Subject: FW: Planning Application RM/24/98388
Attachments: Silt and Sedimentation Mitigation Strategy v1.1.pdf; 203_B_Proposed Drainage Layout Plan - Sheet 2 of 3.pdf

Subject: RE: Planning Application RM/24/98388

Section A-A Through Basins (2x vertical exaggeration)

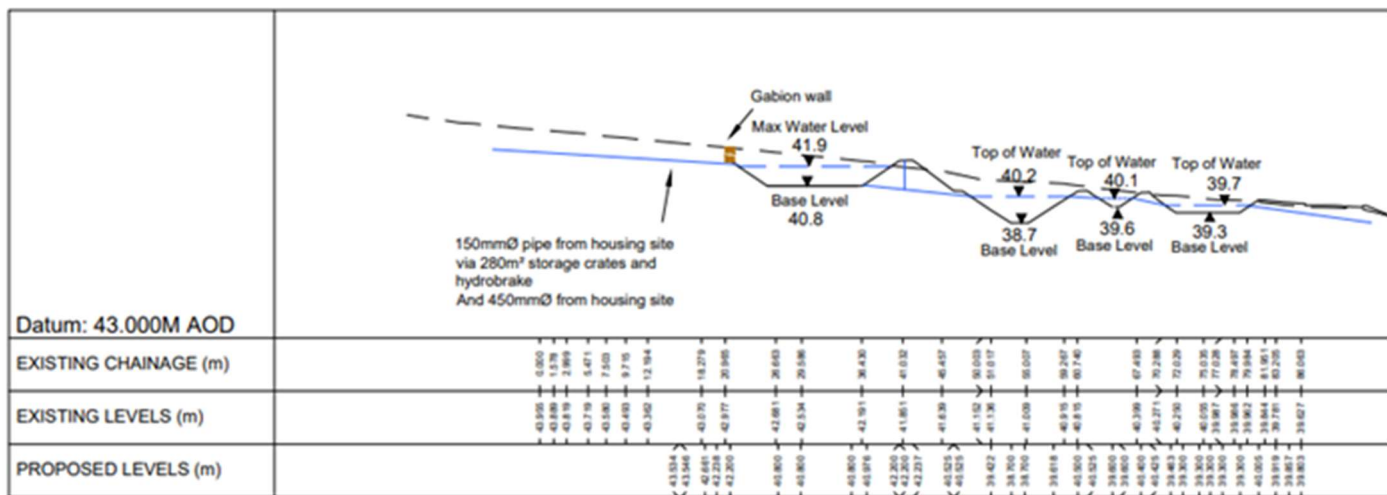
We can confirm that we are not proposing any raised islands within the drainage attenuation scheme. The landscaping plan doesn't quite illustrate the basins as they are shown on the Drainage Layout plan, which shows gradient lines to these areas within the basin – so they are just gradient lines and not islands (see attached and below). The reeds however do form part of the silt and sediment mitigation (see attached report). Sections are available from page 21 of this report. We are proposing to fence the north of the first basin, and the remainder will be open. However, this is subject to a RoSPA review.
